DEVELOPMENT APPLICATION ASSESSMENT REPORT

Application Number:	DA2024/1377
----------------------------	-------------

Responsible Officer:	Anaiis Sarkissian
Land to be developed (Address):	Lot 2 DP 224548, 20 Rednal Street MONA VALE NSW 2103 Lot LIC 613884, 20 Rednal Street MONA VALE NSW 2103
Proposed Development:	Alterations and additions to a dwelling house including a shed
Zoning:	C4 Environmental Living
Development Permissible:	Yes
Existing Use Rights:	No
Consent Authority:	Northern Beaches Council
Land and Environment Court Action:	No
Applicant:	Anthony Dudley James Saddington

Figure 21: Original NW Elevation

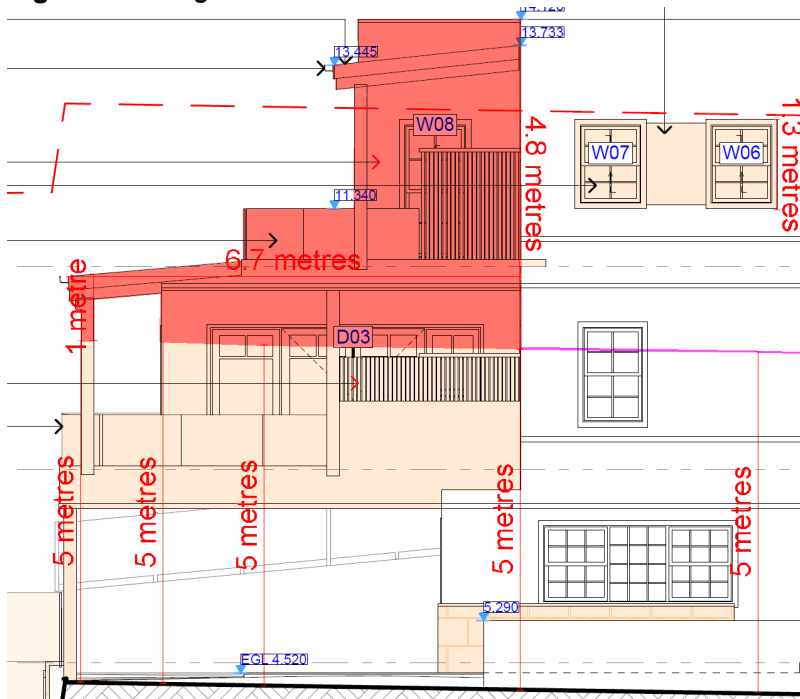
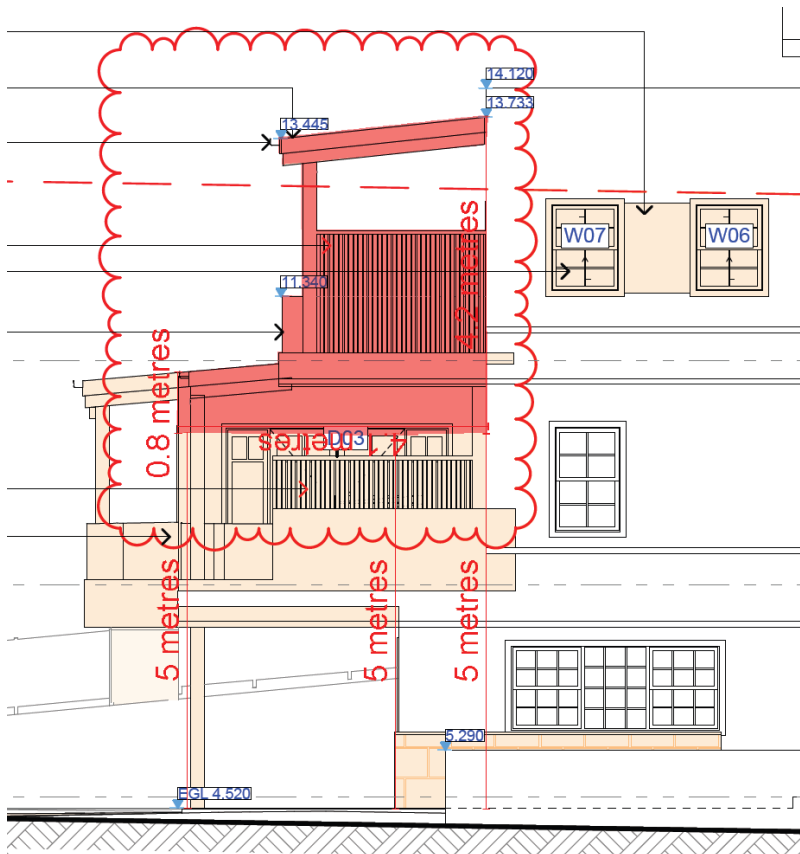
The north-western elevation presents one encroachment of between 0.8m and 4.2m in height for a length of 4.1m, resulting in a maximum variation of 84% (4.2m), as shown shaded red in Figure 22 below.

It is important to note that the original design presented an encroachment of between 1.0m and 4.8m in height for a length of 6.7m, resulting in a maximum variation of 96% (4.8m), as shown shaded red in Figure 21 below.

Figure 23: Original SE Elevation

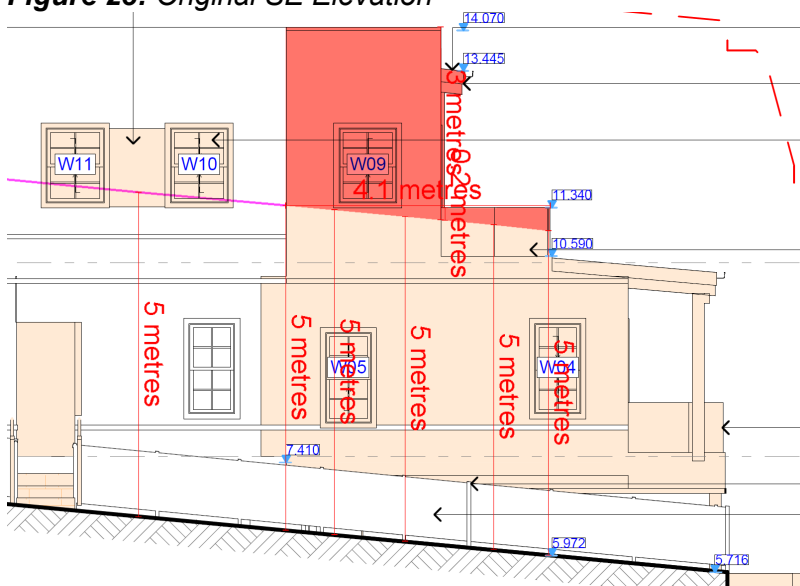
The south-eastern elevation presents one encroachment of 2.4m in height for a length of 2.7m, resulting in a maximum variation of 48% (2.4m), as shown shaded red in Figure 24 below.

It is important to note that the original design presented an encroachment of between 0.2m and 3.0m in height for a length of 4.1m, resulting in a maximum variation of 60% (3.0m), as shown shaded red in Figure 23 below.
